AQUIND INTERCONNECTOR

Request for Changes to the Order Limits

Document Ref: 7.7.17

DATE: DECEMBER 2020

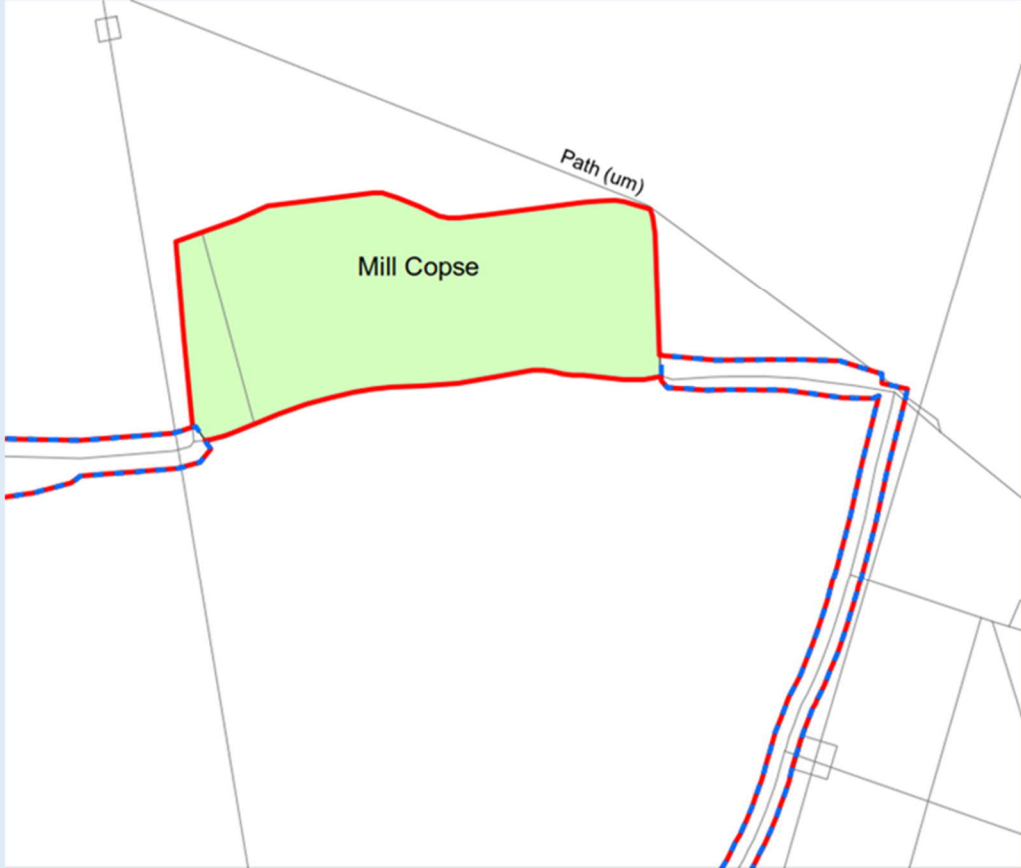
- **Proposed Change 1:** Mill Copse – 10,122 square metres of woodland shown as ‘Woodland A’ in the Ash Dieback Report, and assigned plot number 1-32a in the Updated Land Plans and Addendum to the Book of Reference; and
- **Proposed Change 2:** Stoneacre Copse (ancient woodland) – 14,842 square metres of woodland shown as ‘Woodland F’ in the Ash Dieback Report, and assigned plot number 1-02a in the Updated Land Plans and Supplement to the Book of Reference.

PROPOSED CHANGE 2

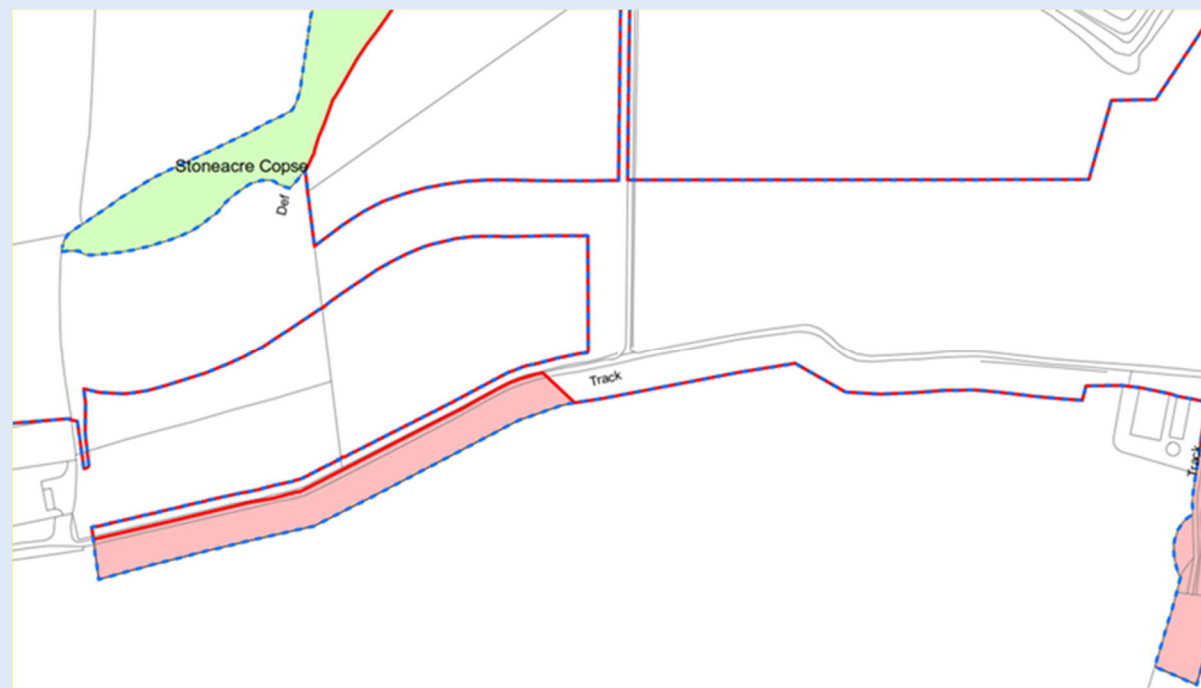
Stoneacre Copse is proposed to be included within the Order limits to enable the Applicant to obtain the right to plant and manage trees in order to mitigate the impact of ash dieback disease on the visual screening of the converter station in future. This is an issue which has been raised by the South Downs National Park Authority, and which led the Applicant's consultants to undertake a further survey of the woodland in proximity to the proposed converter station site. The results of that survey indicated that ash dieback was affecting the ash in this woodland more significantly than had been anticipated. Active management of the ancient woodland is therefore now considered necessary in order to maintain the visual screening which Stoneacre Copse will provide in the long-term.

Ash is present throughout Stoneacre Copse. The southern half of the woodland consists of approximately 80% ash, with oak taking dominance in the northern end up to the access track where the population of ash is approximately 40%.

This woodland provides visual screening from residential properties off Broadway Lane and Broadway Lane (south) as well as recreational receptors to the east, south east and south. The woodland also serves a secondary function in providing a 'layering of woodland', partially screening views from more elevated positions and screening the existing Lovedean substation.

Ash dieback threatens the effectiveness of this woodland to provide visual screening.

The Applicant is attempting to secure the rights required via voluntary agreement but cannot confirm this will be possible. By including this woodland within the Order limits, the Applicant can secure the necessary rights to plant and manage it such that it continues to act as a visual screen despite the effects of ash dieback.

PROPOSED CHANGE 3

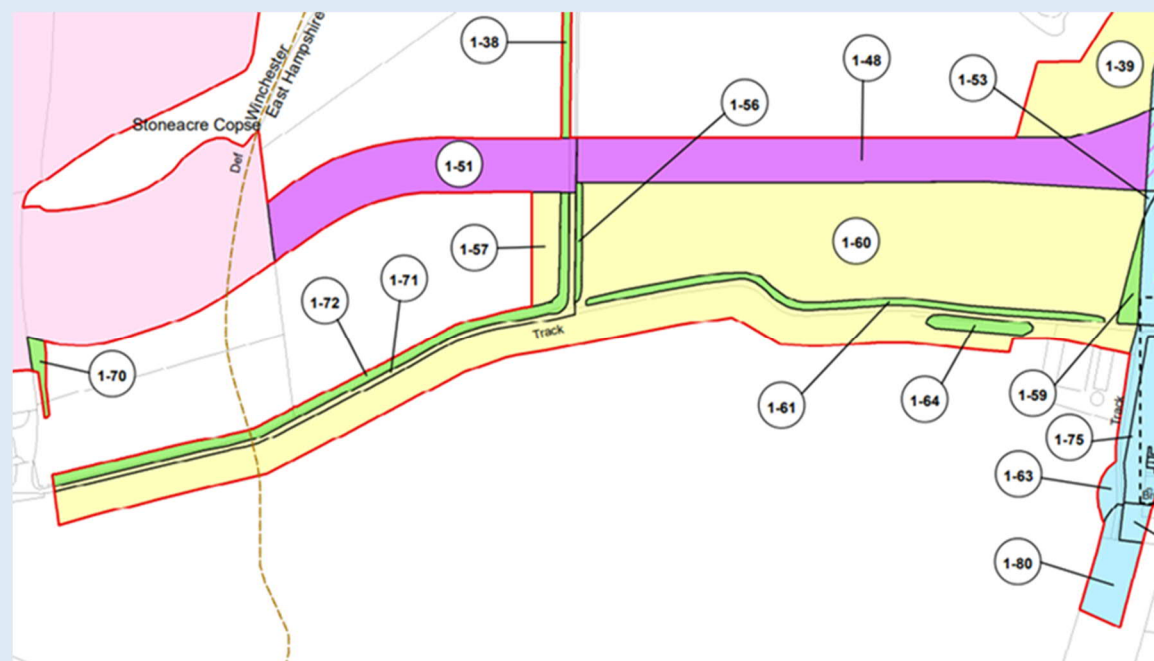
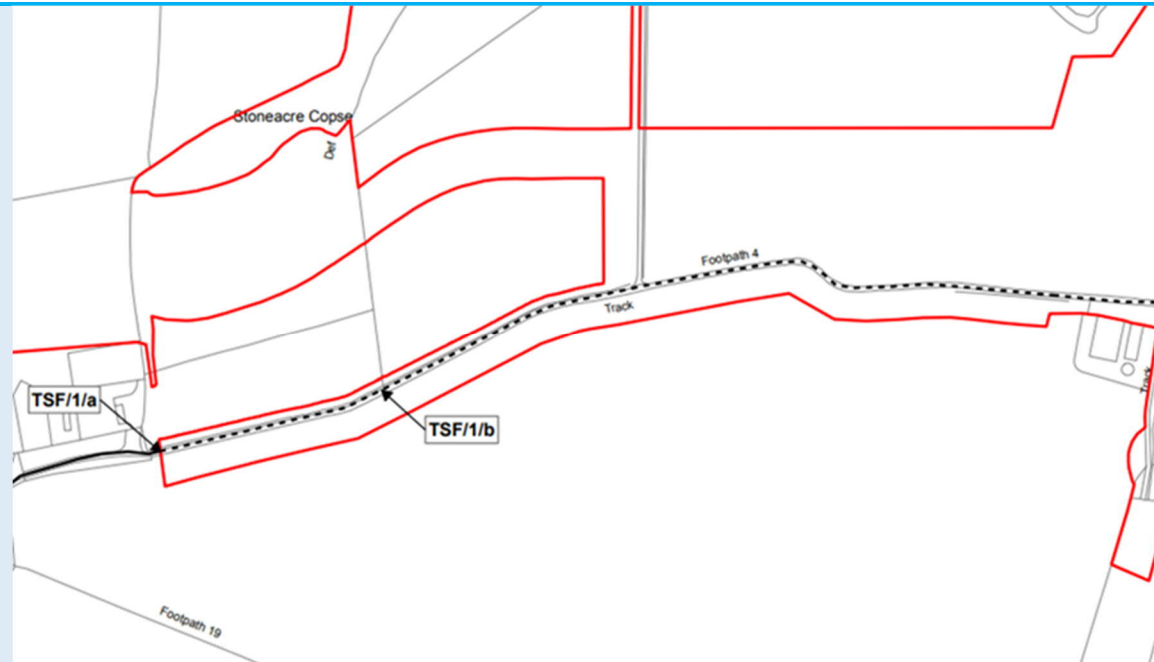
The permanent access road to the converter station site will provide the access required during the operational phases and also during the majority of the construction phase (i.e. once the road has been constructed).

To facilitate access for plant and machinery while the access road is being constructed, temporary use is required over the existing farm track in the southern parts of plot 1-60, as well as across the farm track identified as plot 1-71. The southern parts of plot 1-60 were intended to facilitate the temporary diversion of the public right of way (part of footpaths 16 and 4 which run through plot 1-71) over the farm track which sits within plot 1-60 should that be required.

Further assessment has, however, concluded that in the event it is necessary to divert the public right of way, this would not need to take place in the areas proposed to be removed from the Order limits, and the Applicant has no other need to temporarily use this area. As such it can be removed from the Order limits.

PROPOSED CHANGE 4

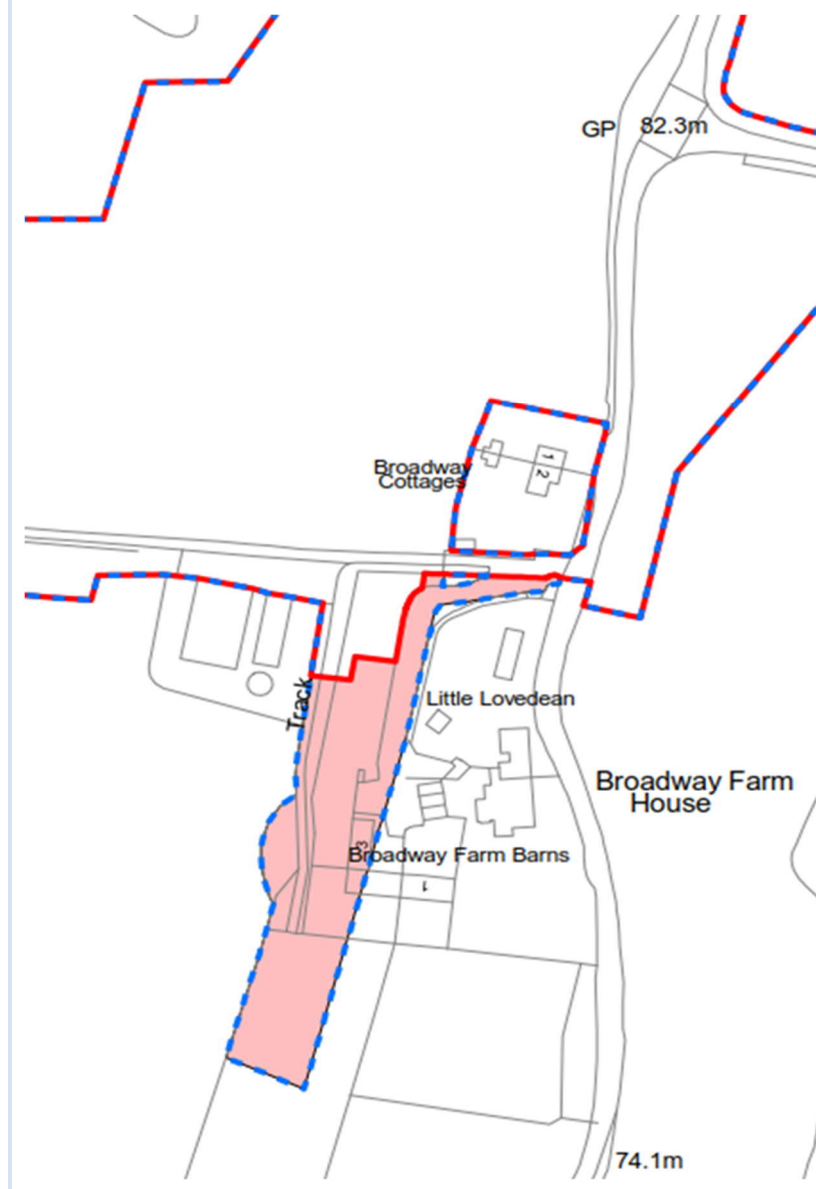
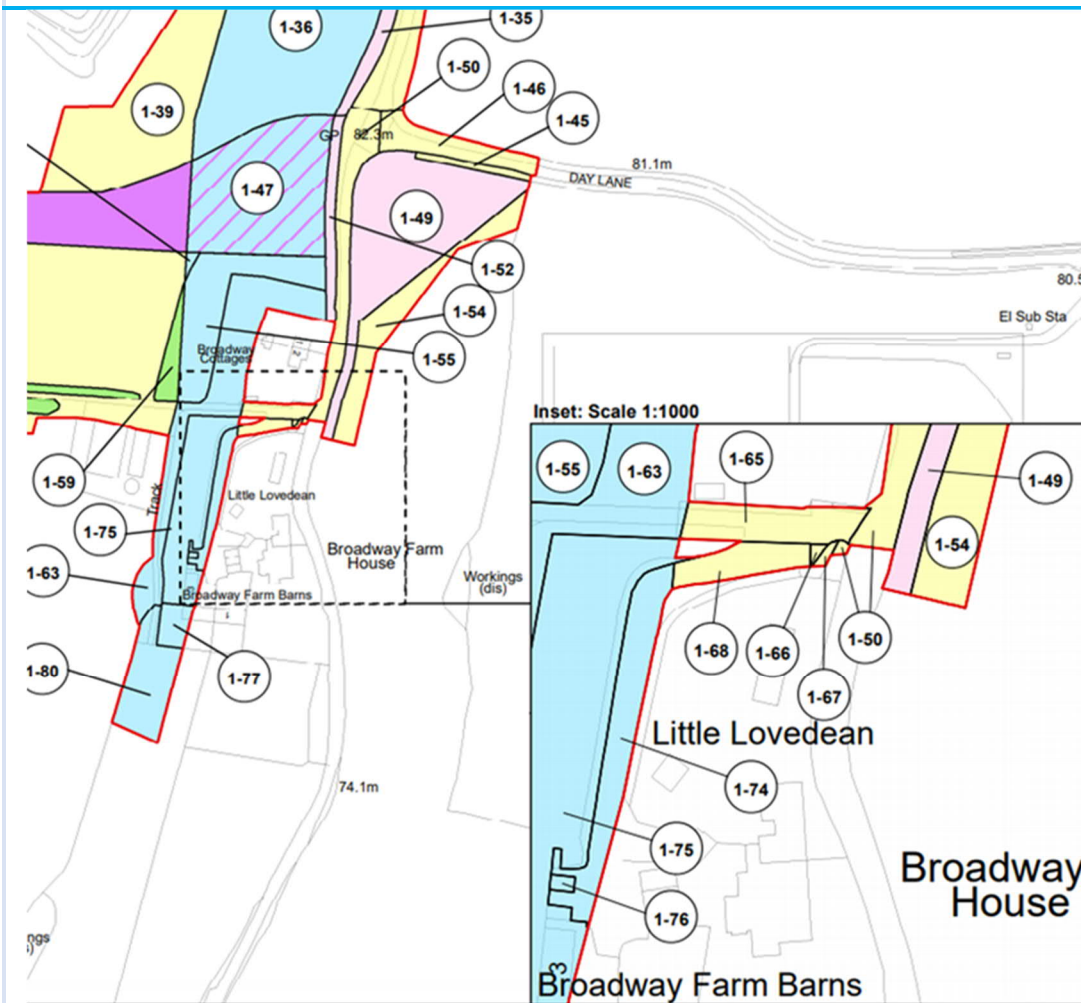
Reduction of Order limits affecting: plots 1-66, 1-67, 1-68, 1-74, 1-76, 1-77, 1-80 (all removed in their entirety); and removal of plot 1-50 (in part), 1-63 (in part) and 1-75 (in part).

One of the enabling activities which will be required to facilitate the construction of the new access road in plots 1-52, 1-47, 1-48, 1-51 and 1-32 is the undergrounding of the existing 11kv overhead line ('OHL') which runs north to south through plots 1-33, 1-36, 1-47, 1-55, 1-63, 1-74, 1-75, 1-76, 1-77 and 1-80. The OHL is owned and operated by SSE Services Plc as Local Distribution Network Operator ('SSE').

The Order limit in this area was based on undergrounding works taking place from a pole located in plot 1-80, which would have required access over the plots located north of this in association with the undergrounding works.

Following further assessment, the Applicant is confident the undergrounding would not take place from the pole located in plot 1-80 but would instead take place from a pole located on the northern boundary of plot 1-55, adjacent to the existing farm track which runs through plot 1-63. An area south of this pole, has been retained as it is likely SSE would need access over it in association with undertaking the works.

As a result the Applicant will not need to secure New Connection Works Rights over plots 1-74, 1-76, 1-77 and 1-80, and the area over which rights are sought at plots 1-63 and 1-75 can be substantially reduced. Furthermore temporary use of plots 1-66, 1-67 and 1-68, which were identified to provide temporary access associated with undertaking the works are not required and only part of plot 1-50 is now required for such temporary use.

**Appendix 1 – Plan
showing a comparison of
the Order limits (as
varied by the changes
accepted by the ExA in
their procedural decision
dated 11 November 2020)
with the Order limits as
now proposed**

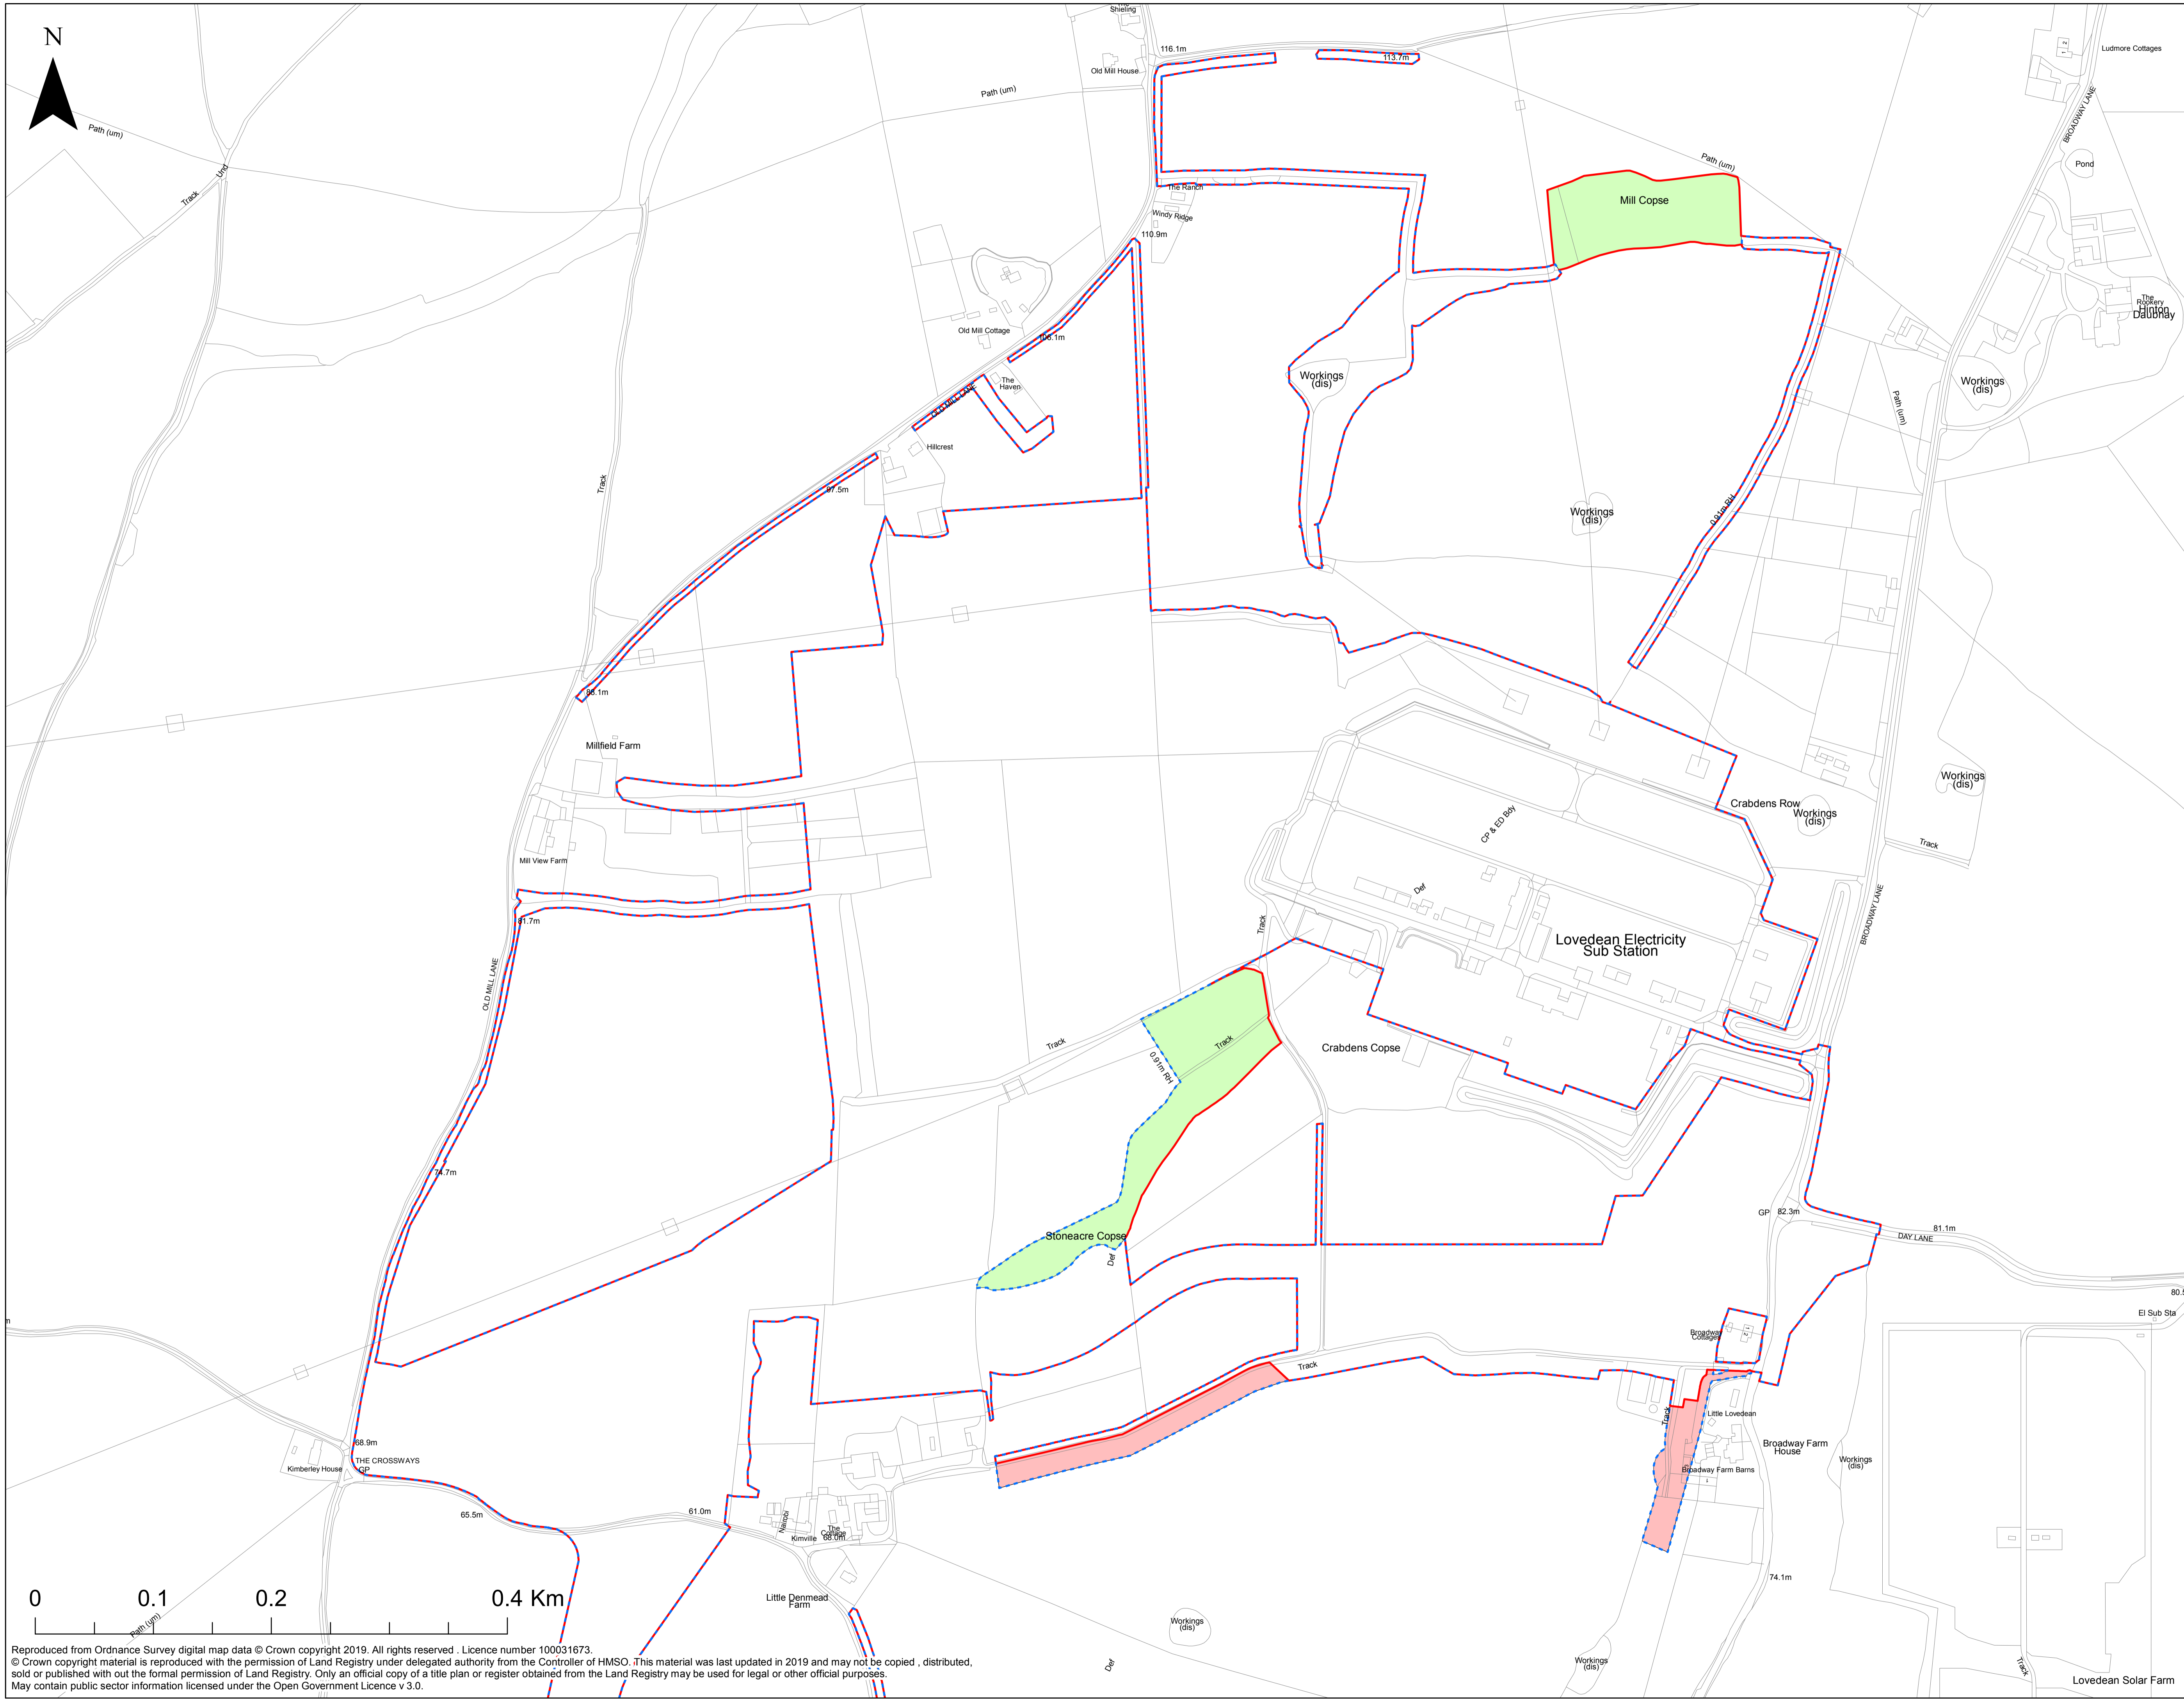
- 2.1.1.4. Areas removed from the Order limits (**Proposed Changes 3 and 4**) are shown shaded in pink, and the two new plots of land over which New Landscaping Rights are sought (**Proposed Changes 1 and 2**) are shown shaded in green.
